BEN LOMAND MOUNTIAN VILLAGE

PRELIMINARY PLAT

BEN LOMAND MOUNTAIN VILLAGE

PRELIMINARY PLAT

PROJ MGR: SLJ
PROJ ASSOC: SLJ
DRAWN BY: CAD
DATE: 1/22/26
SCALE: 1" = 100'
SHEET
9 OF 23
UNC.MOCC001

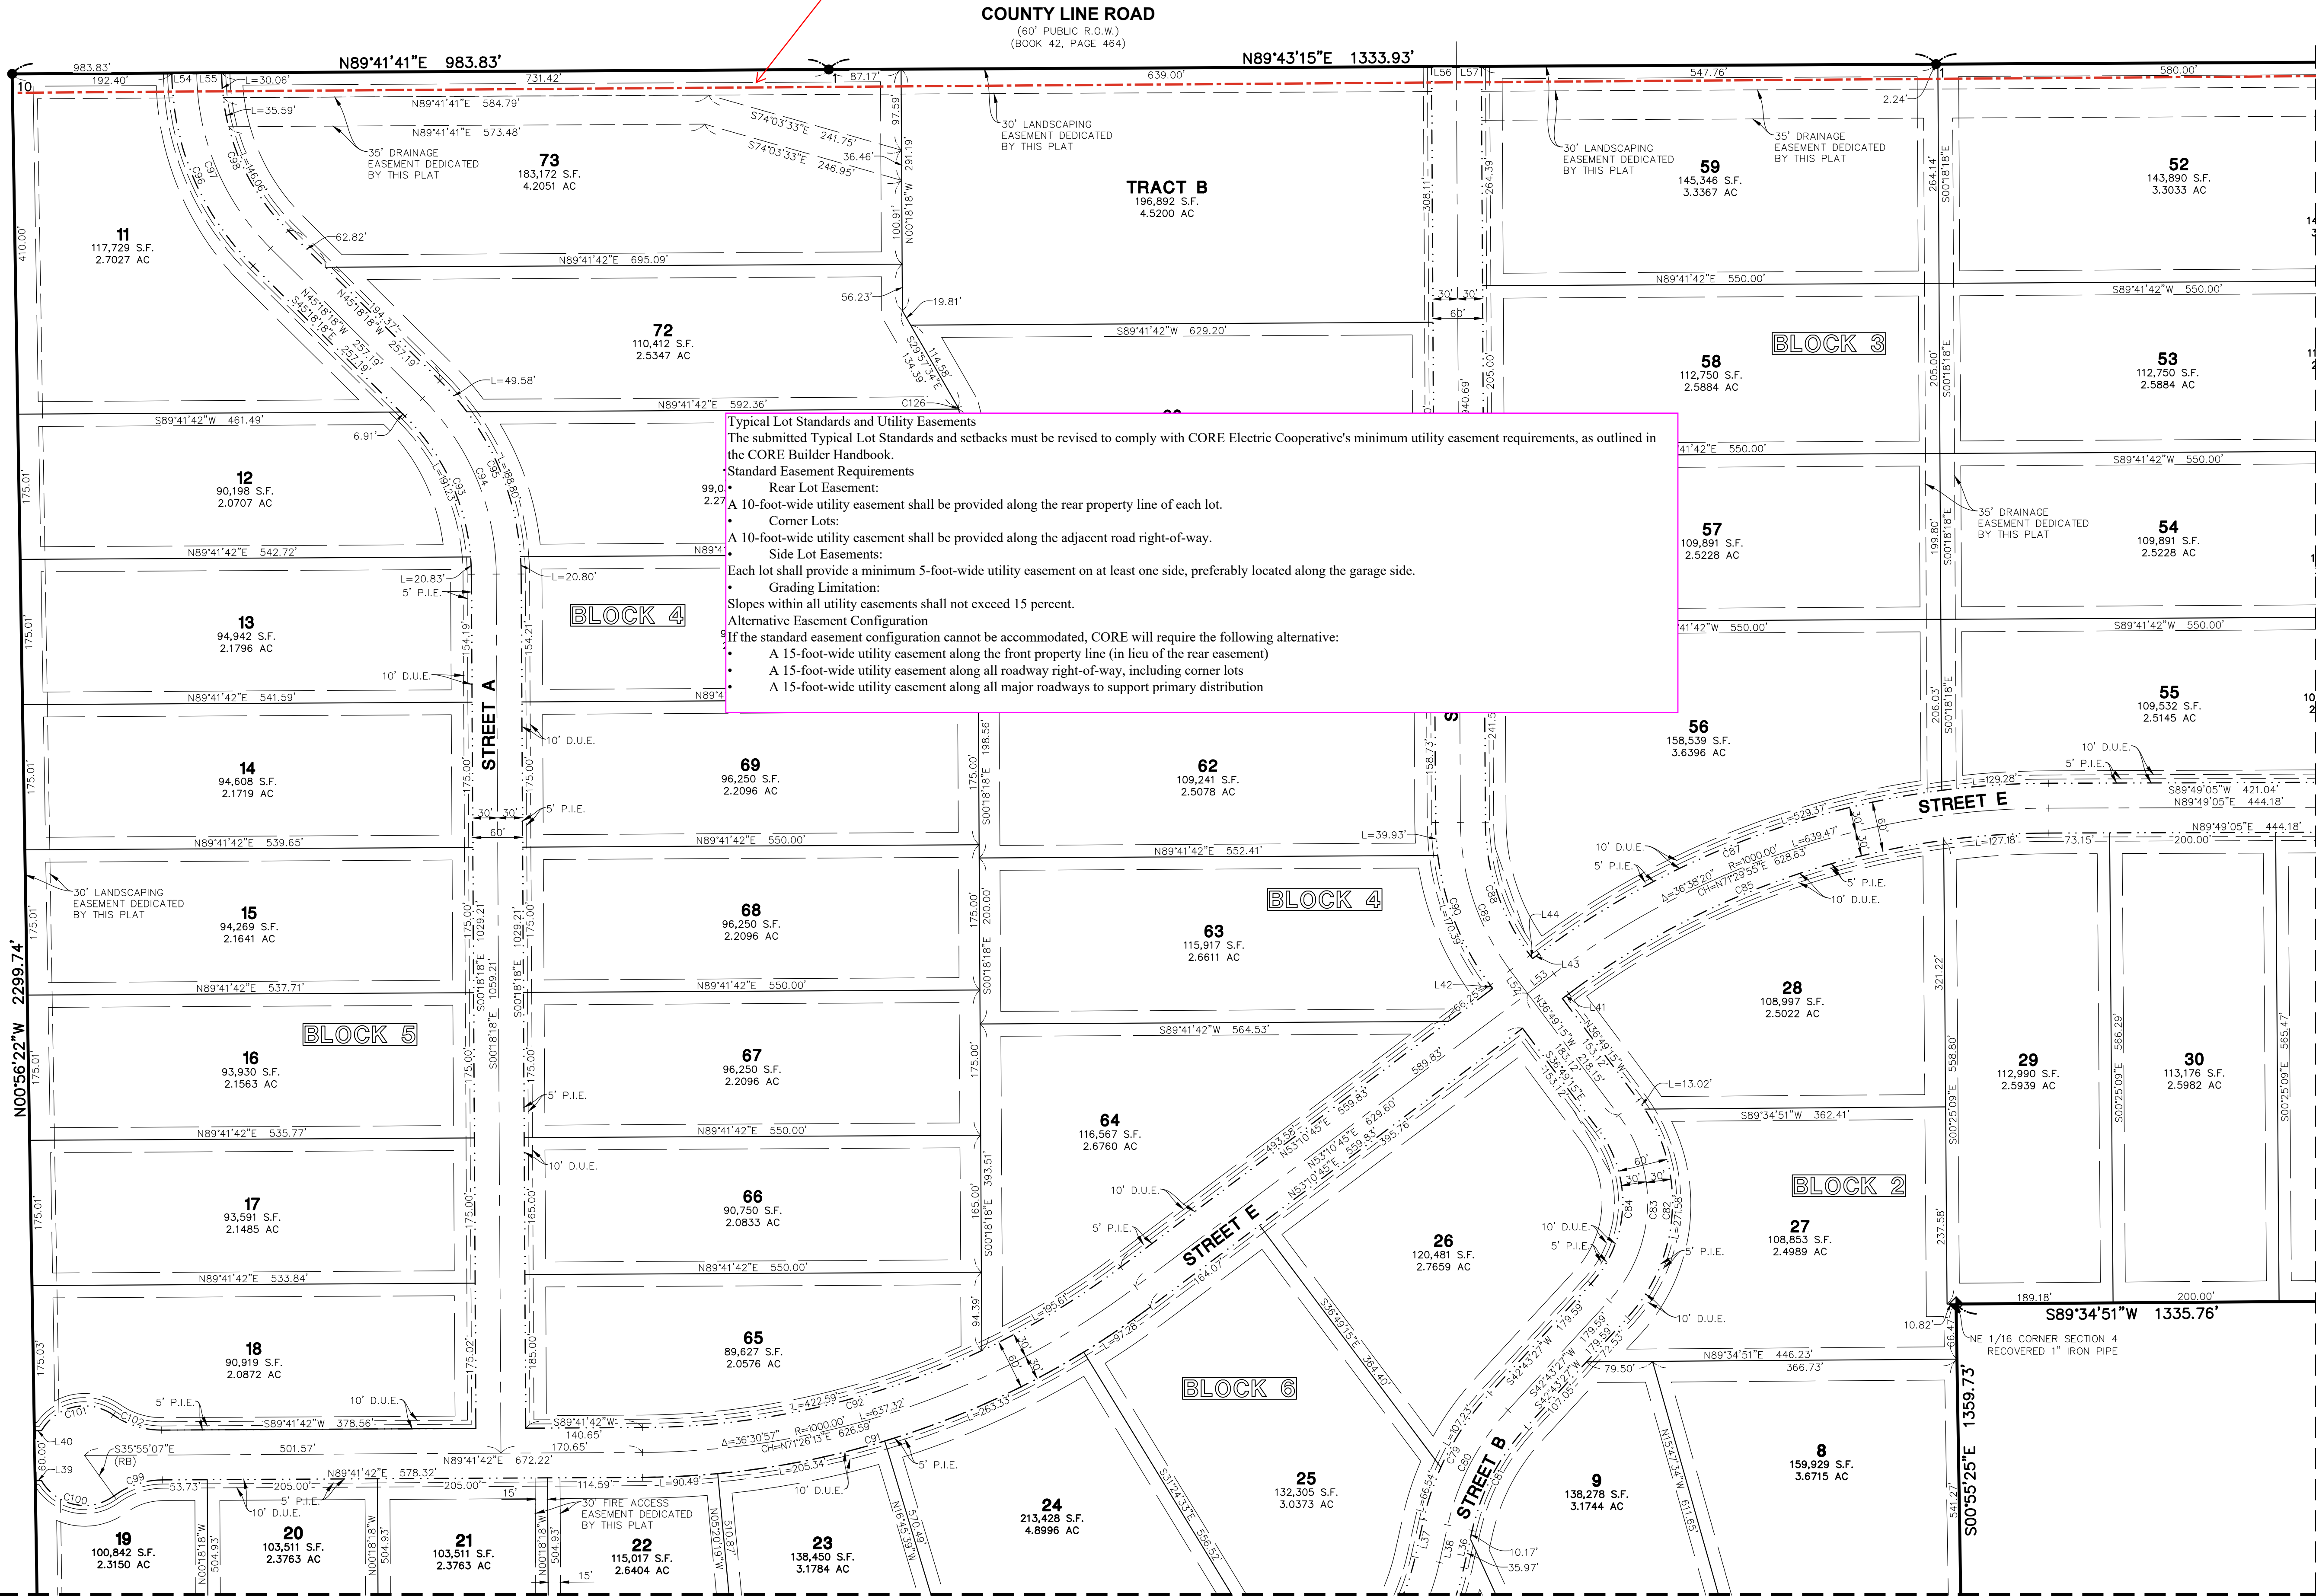
CORE WILL REQUIRE 15-FOOT UE

NO STRUCTURES INCLUDING COLUMNS FOR PROPOSED FENCE MAY ENCR OACH INTO UE

Typical Lot Standards and Utility Easements
The submitted Typical Lot Standards and setbacks must be revised to comply with CORE Electric Cooperative's minimum utility easement requirements, as outlined in the CORE Builder Handbook.

- Rear Lot Easement:
 - A 10-foot-wide utility easement shall be provided along the rear property line of each lot.
- Corner Lots:
 - A 10-foot-wide utility easement shall be provided along the adjacent road right-of-way.
- Side Lot Easements:
 - Each lot shall provide a minimum 5-foot-wide utility easement on at least one side, preferably located along the garage side.
- Grading Limitation:
 - Slopes within all utility easements shall not exceed 15 percent.

If the standard easement configuration cannot be accommodated, CORE will require the following alternative:

- A 15-foot-wide utility easement along the front property line (in lieu of the rear easement)
- A 15-foot-wide utility easement along all roadway right-of-way, including corner lots
- A 15-foot-wide utility easement along all major roadways to support primary distribution

SHEET
10 OF 23
UNC.MOCO01

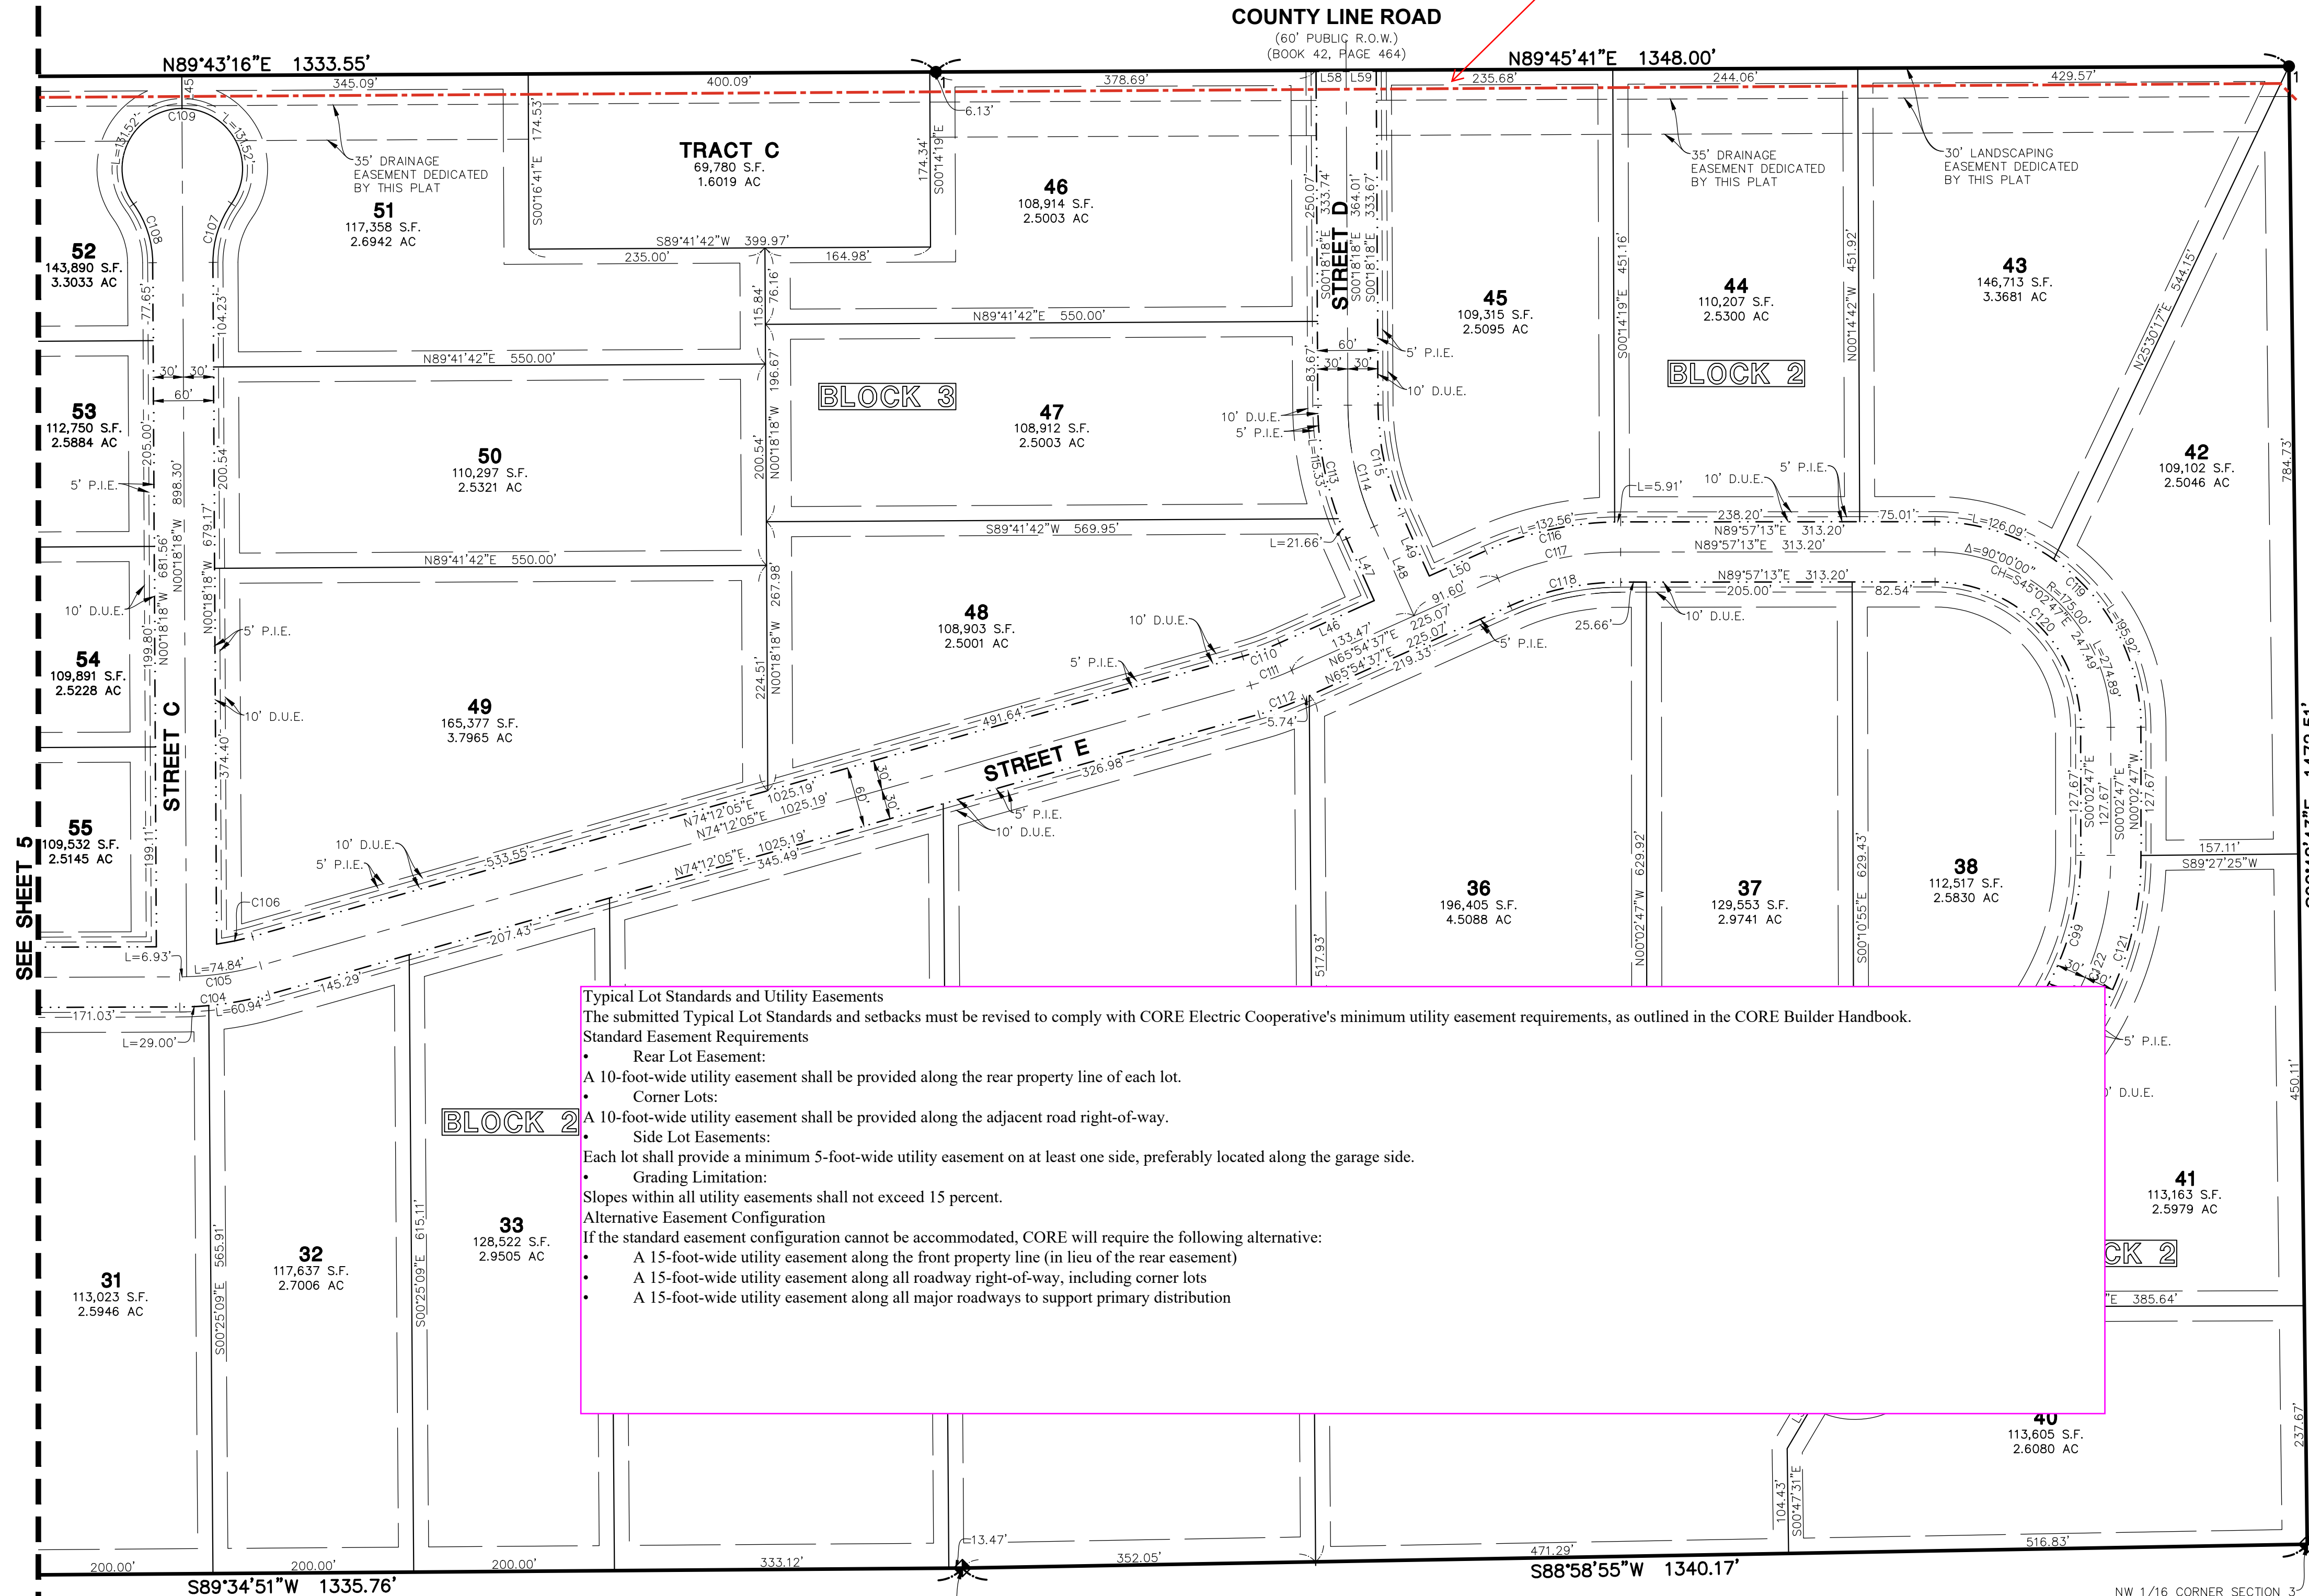
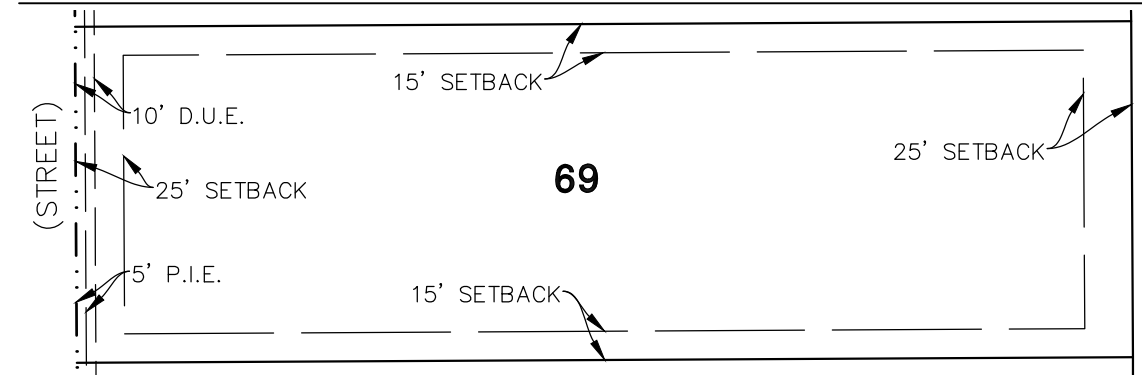
CORE WILL REQUIRE 15-FOOT UE
NO STRUCTURES INCLUDING COLUMNS FOR
PROPOSED FENCE MAY ENCR OACH INTO UE

Typical Lot Standards and Utility Easements
The submitted Typical Lot Standards and setbacks must be revised to comply with CORE Electric Cooperative's minimum utility easement requirements, as outlined in the CORE Builder Handbook.

- Rear Lot Easement:
A 10-foot-wide utility easement shall be provided along the rear property line of each lot.
- Corner Lots:
A 10-foot-wide utility easement shall be provided along the adjacent road right-of-way.
- Side Lot Easements:
Each lot shall provide a minimum 5-foot-wide utility easement on at least one side, preferably located along the garage side.
- Grading Limitation:
Slopes within all utility easements shall not exceed 15 percent.

Alternative Easement Configuration
If the standard easement configuration cannot be accommodated, CORE will require the following alternative:

- A 15-foot-wide utility easement along the front property line (in lieu of the rear easement)
- A 15-foot-wide utility easement along all roadway right-of-way, including corner lots
- A 15-foot-wide utility easement along all major roadways to support primary distribution
